Groundwater Application Review Summary Form

Application # G- 18843

GW Reviewer Ben Scandella, Jen Woody Date Review Completed: 1/10/2022

PUBLIC INTEREST REVIEW FOR GROUNDWATER APPLICATIONS

Hydrograph showing water level elevations in nearby wells

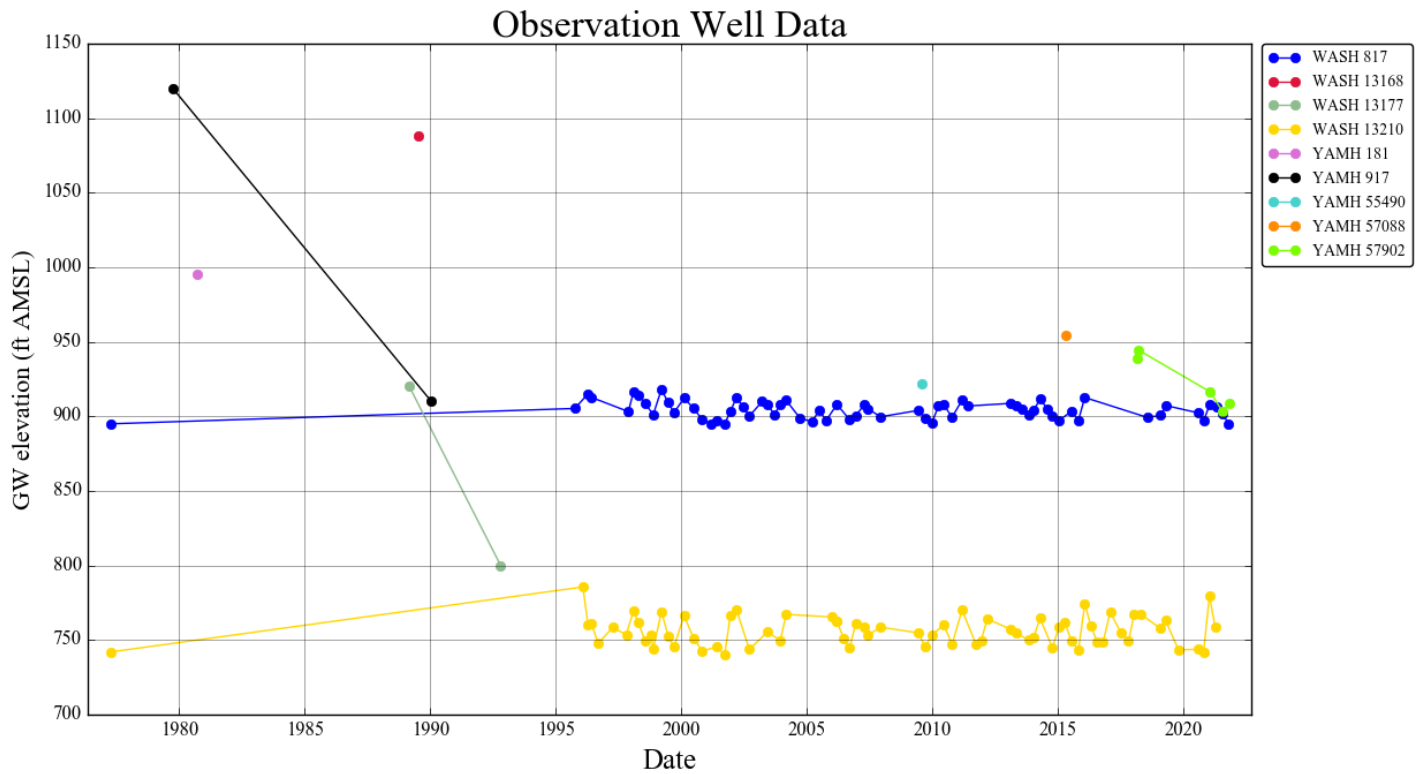
basalt wells have been deepened, including YAMH 917 and WASH 13177. The new proposed well location is at elevation 1355 feet, which is only 400 feet above the top of most recent water levels in nearby basalt wells, between 895 to 955 feet (see hydrograph below). The deepening of nearby shallow wells, combined with recent water levels below the bottom of the proposed "400 feet (TBD)" depth, suggest that the subject well would need to be drilled up to 500 feet deep in order to access a productive aquifer. The nearest analogous well, YAMH 56904 was drilled over 500 feet deep and has still experienced significant declines. Therefore, even with a deeper well, the **deepenings and declining water levels suggest that the proposed use is likely not within the capacity of the resource.**

Impacts on YAMH 917 at the proposed rate, 0.019 cfs:

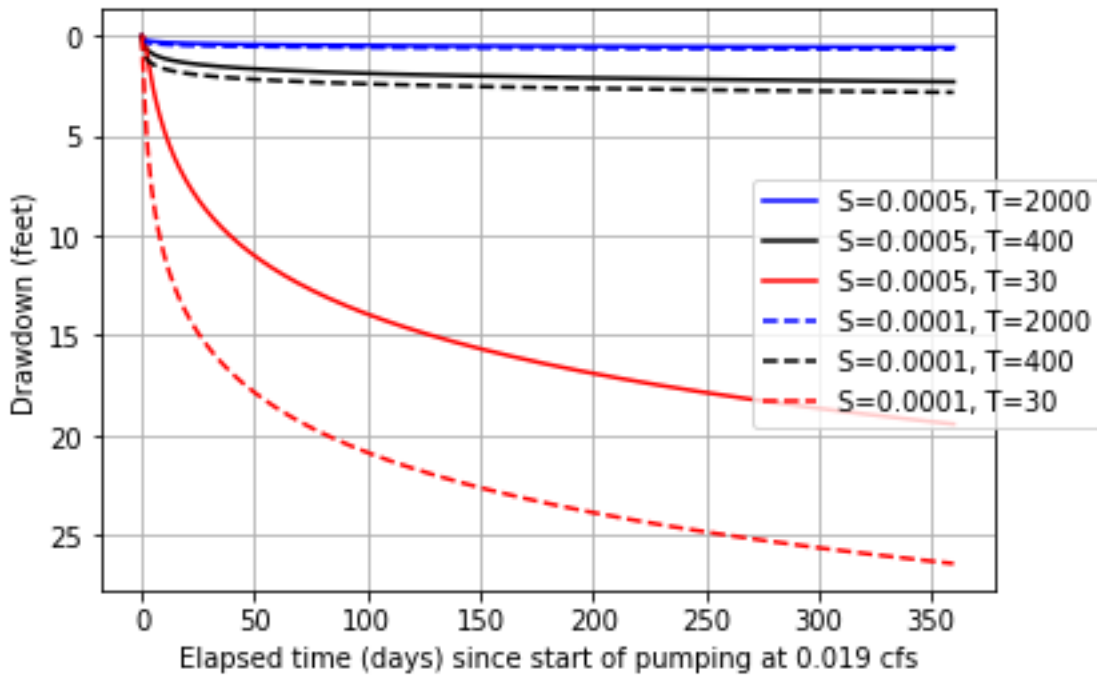
Only one permitted basalt irrigation well (YAMH 928, at about 3600 feet to the west, on Certificate 48416) occurs within a 1-mile radius of the proposed well. However, tax lot maps and the OWRD well log database indicate that at least 50 domestic wells lie within a 1-mile radius. Potential impacts to existing wells from the proposed well are difficult to assess because of a lack of knowledge about local hydraulic properties and the geometry of individual aquifers. The well most likely to experience greatest interference depends on the construction of the subject well; if it is limited to 400 feet, then YAMH 917 (about 750 feet northeast) would be the nearest well likely to intersect a matching water-bearing zone, but if the well depth is 500 feet, then YAMH 55490 would likely also be affected and is closer (280 feet to the northwest). Their modeling suggests that interference with YAMH 917 could range between 1 and 30 feet over 1 year of continuous pumping, depending on aquifer properties derived from nearby pumping tests in the CRBG. However, interference is likely to be limited to less than 5 feet, which is not likely to cause Substantial or Undue Interference. Interference with YAMH 55490 would be somewhat larger due to its proximity, but interference would still likely be limited to 5 feet within 1 year. In case a permit is issued, the potential for significant interference within the range of plausible aquifer properties indicates the aquifer test condition below.

This drawdown at r = 750 ft from pumping well

4. Other conditions as required by OAR 690-502-0200
 5. For any well drilled under a permit issued pursuant to this application, a constant-rate aquifer test shall be conducted before beneficial use of the well begins to determine aquifer properties and to assess the potential impacts from use of the well. The test shall be designed and conducted by an Oregon Registered Geologist, and the test design shall be subject to the approval of the Groundwater Section of the Department prior to the test. At a minimum, the test shall include discharge and water-level measurements in the pumping well and simultaneous water-level measurements in all other wells drilled under this water right. Simultaneous water-level measurements shall also be made in YAMH 55490, YAMH 917, YAMH 57088, YAMH 57902, and WASH 13168, or in substitute wells approved by the Groundwater Section of the Department. The applicant will be responsible for obtaining permission from the owners of these wells to monitor their water levels throughout the aquifer test. Additionally, water-level measurements shall be made at a minimum of one observation well that is constructed to a similar bottom elevation as the pumping well, and with a similar open interval. The observation well shall be at least 500 feet from the production well and shall be constructed by the applicant and maintained as a dedicated observation well for the duration of groundwater use under this permit. Pumping duration for the test shall be determined by the Groundwater Section of the Department after well yield and specific capacity are determined. The results of each aquifer test shall be presented in a report to the Department that includes an analysis of aquifer properties, aquifer boundaries, and the potential impact on nearby wells that is likely to occur over the duration of an irrigation season if the well is used at the proposed rate and duty. Use of the well under this permit shall not be authorized until the test report is approved by the Groundwater Section of the Department. If the test results combined with Theis modeling suggest that any well would experience more than 15 feet of interference over a 365-day period of continuous pumping at the permitted rate, then the authorized pumping rate on this permit shall be reduced to a level that reduces the modeled interference to less than 15 feet, as determined by Department Groundwater Section staff. The permittee shall allow Department staff access to install water-level monitoring equipment prior to any aquifer tests and for the duration of any permitted water use pursuant to this application.

Impacts on YAMH 55490 at the proposed rate, 0.019 cfs:

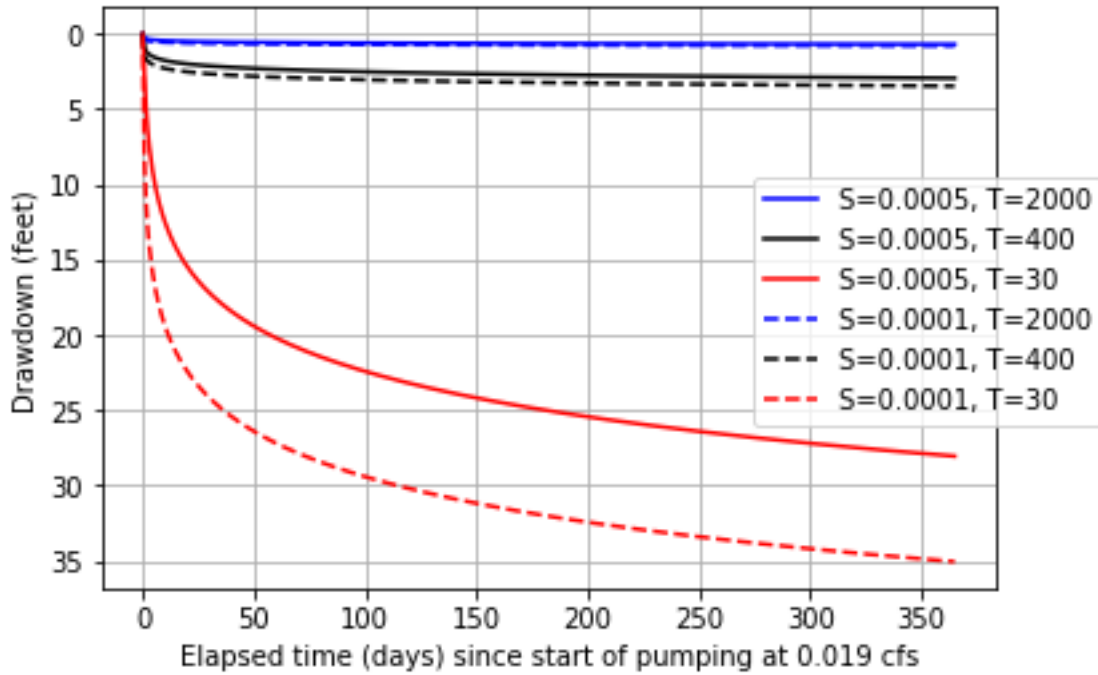
This drawdown at r = 280 ft from pumping well
